KEYSTONE WOODS LAKE DAM (29-5)

2025 Dam Safety Inspection Report

Hamilton County, IN | November 2025

Inspection Date: July 25, 2025

APPENDIX 4: INSPECTION PHOTOGRAPHS

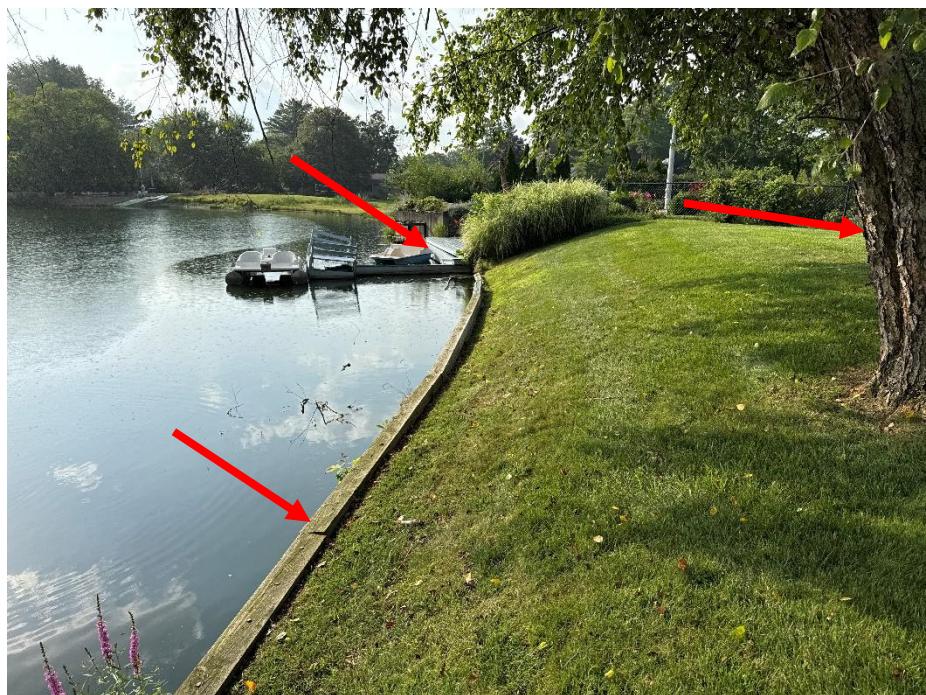
Top: Upstream slope right side. Note timber seawall protection on this section with slight deflection towards lake. Also note several encroachments of fences, trees, and bushes.
